Riverside Energy Park

Statement of Common Ground: Environment Agency (Signed)

8.01.11

Statement of Common Ground between the Applicant and The Environment Agency

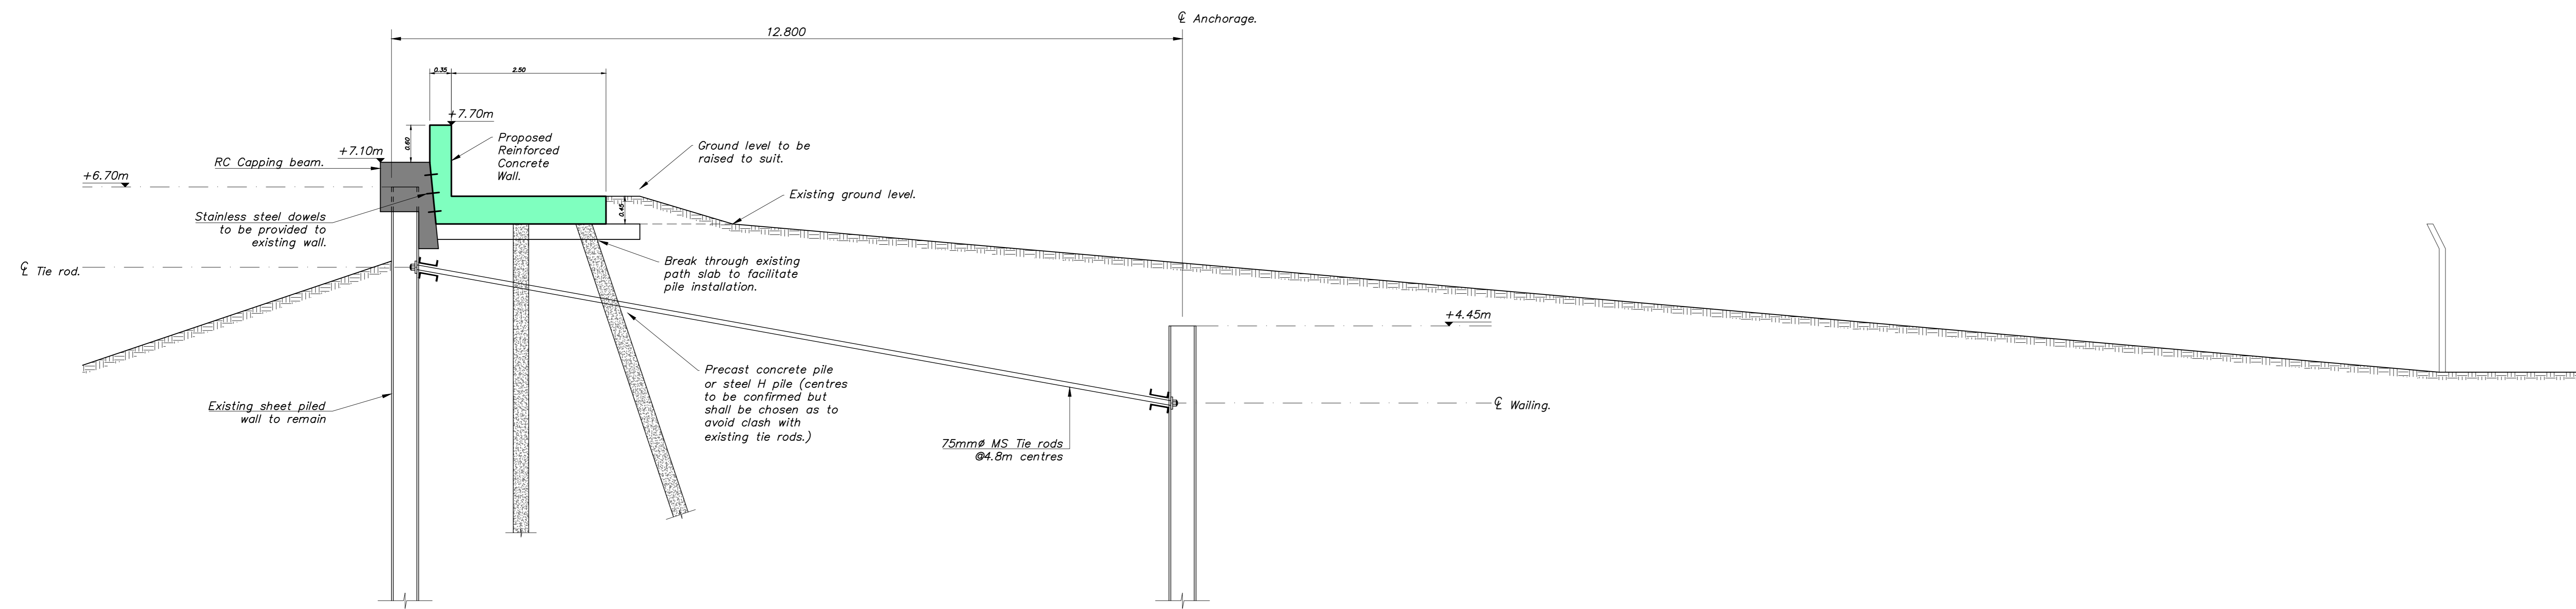
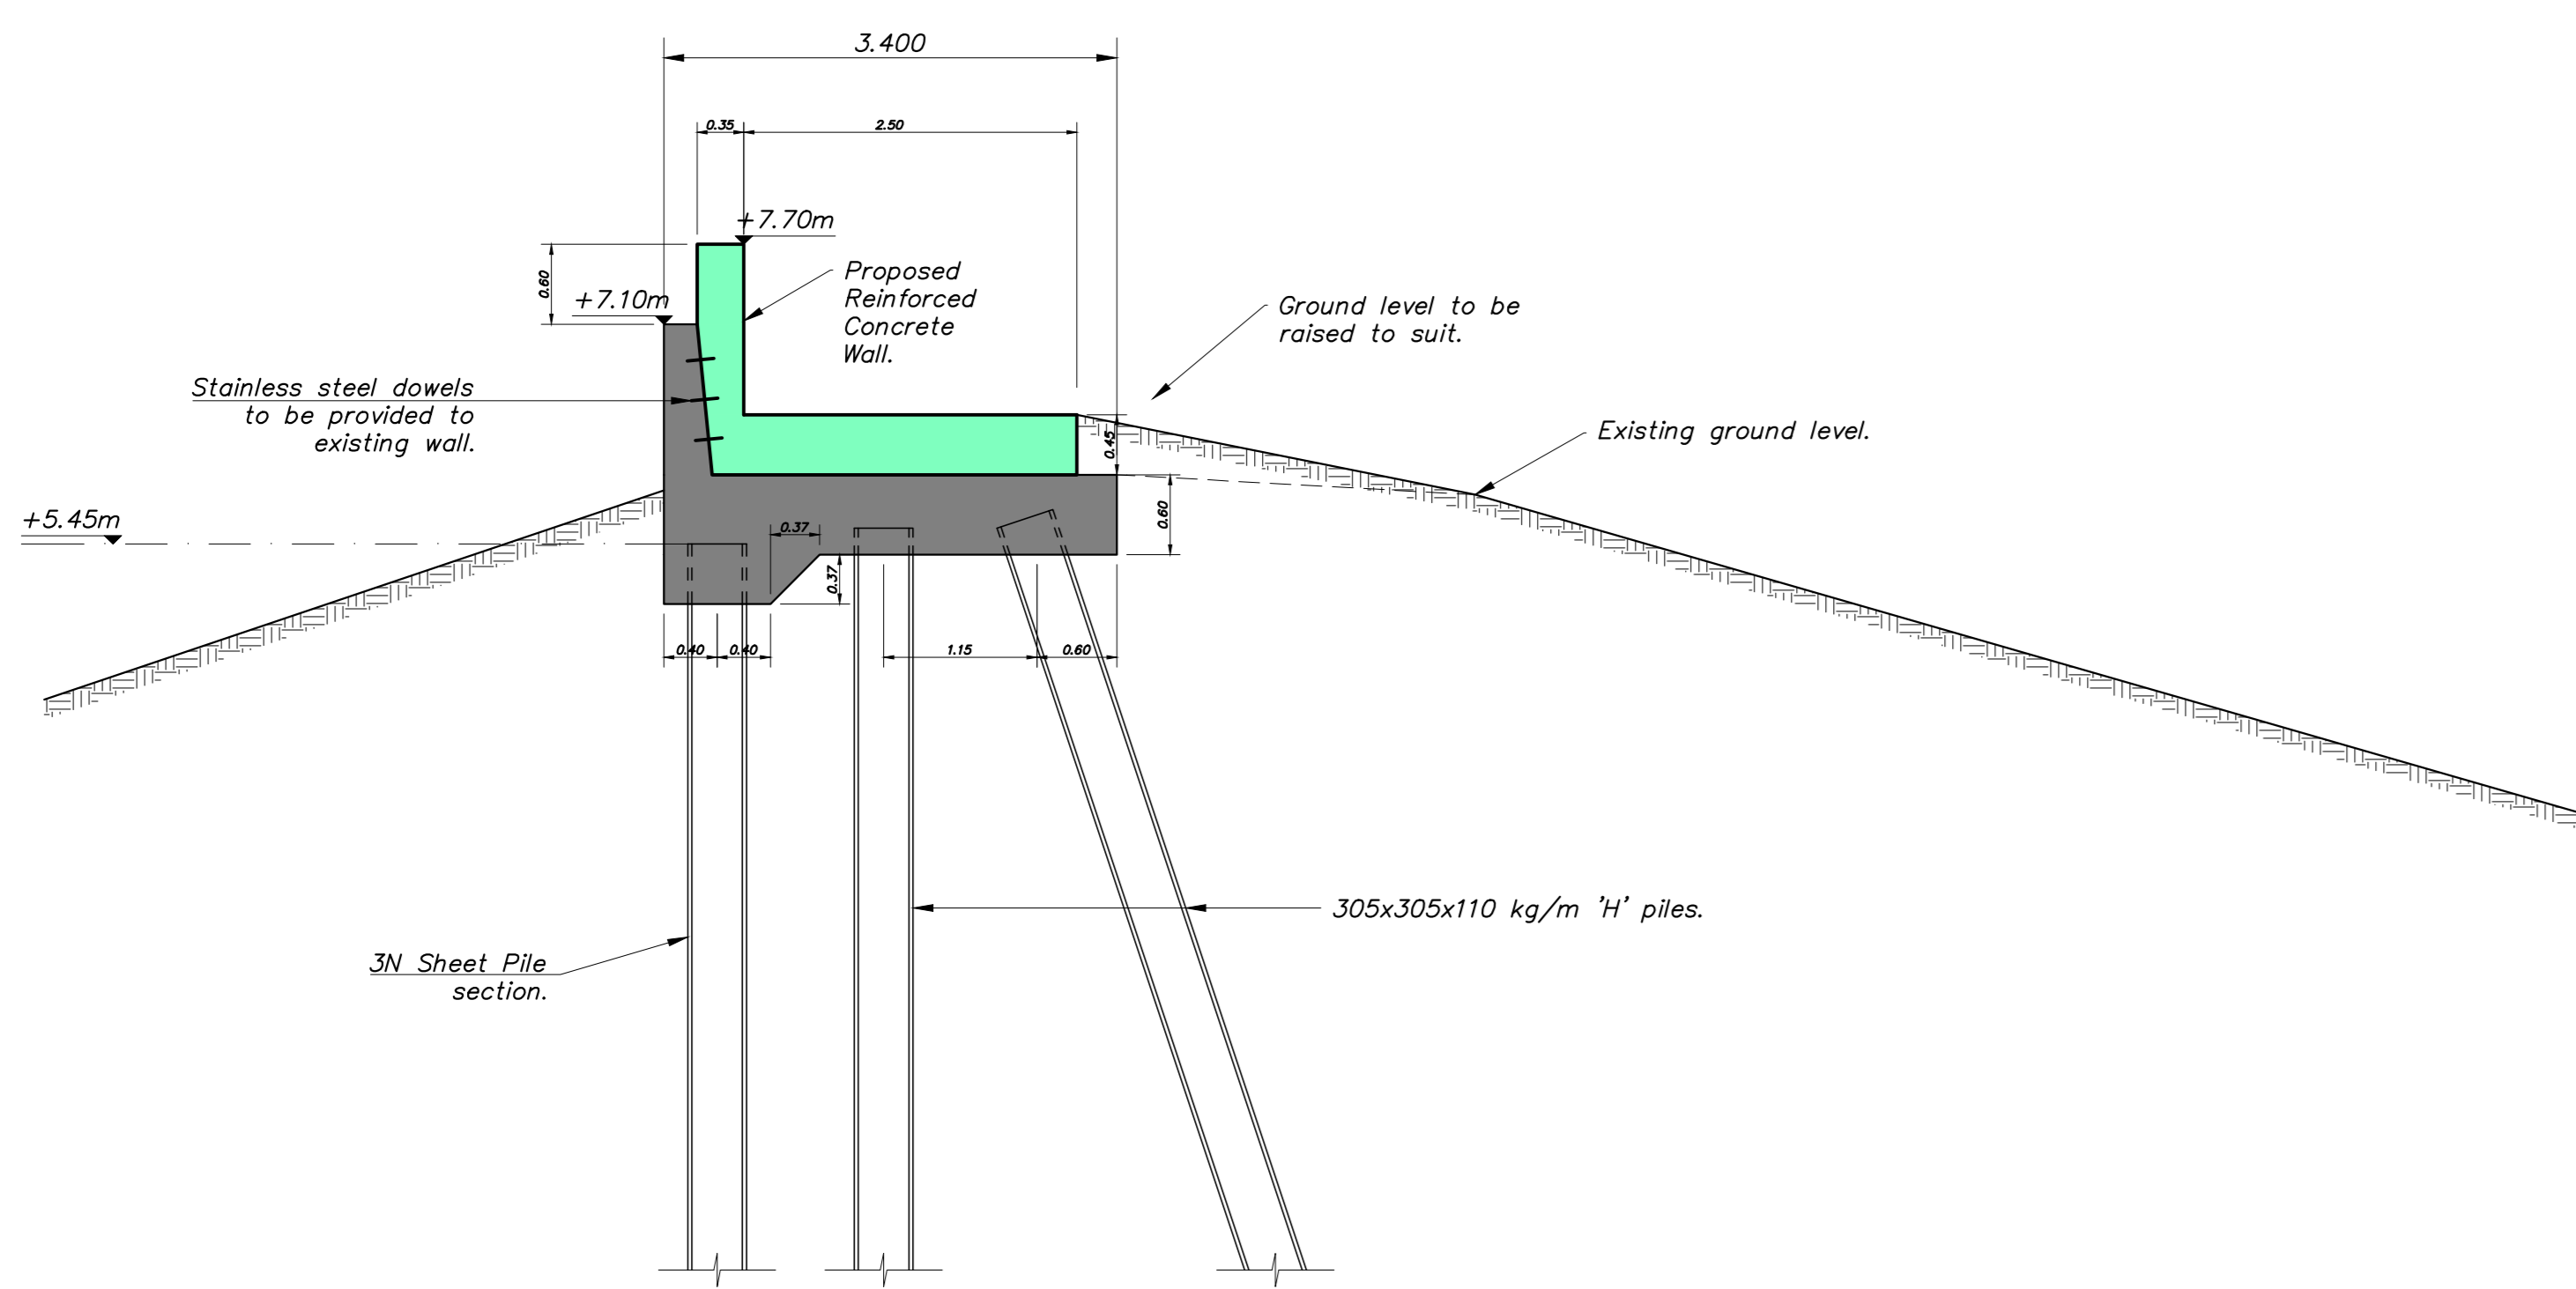
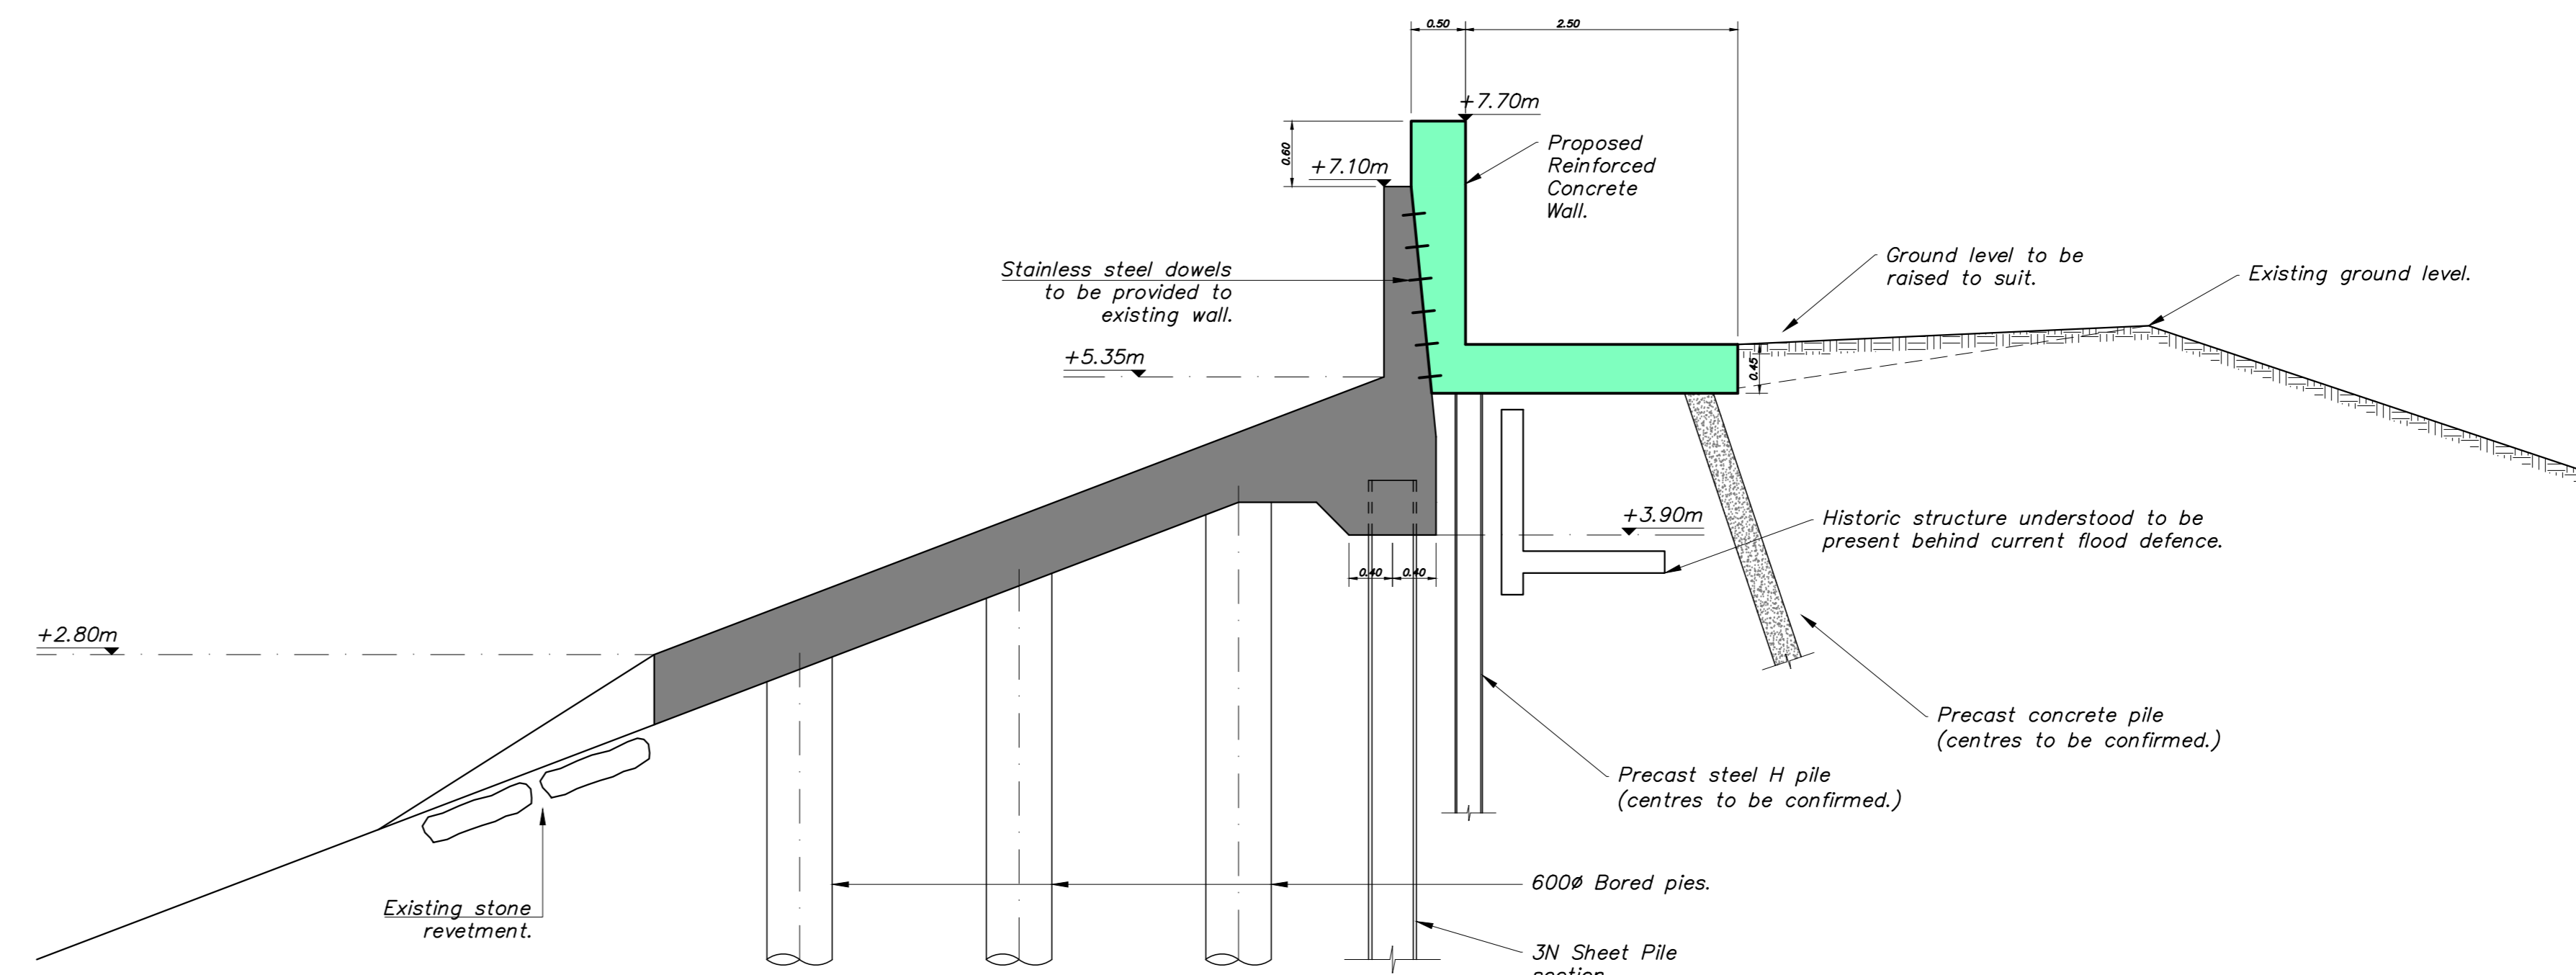
2.2.1 Through the indicative diagrams C110-113 (see **Appendix A** of this SOCG), the Parties agree that it has been demonstrated that the Proposed Development does not preclude the raising of the flood defence to the second stage level (of 7.7m AOD expected in 2070) proposed in the Thames Estuary 2100 Plan, and does not significantly restrict future defence raising options. These illustrative drawings were provided at the request of the EA in order to provide examples of technical solutions that could be adopted in the future should the need ever arise to raise the flood bank in line with the requirements of the Thames Estuary 2100 Plan.
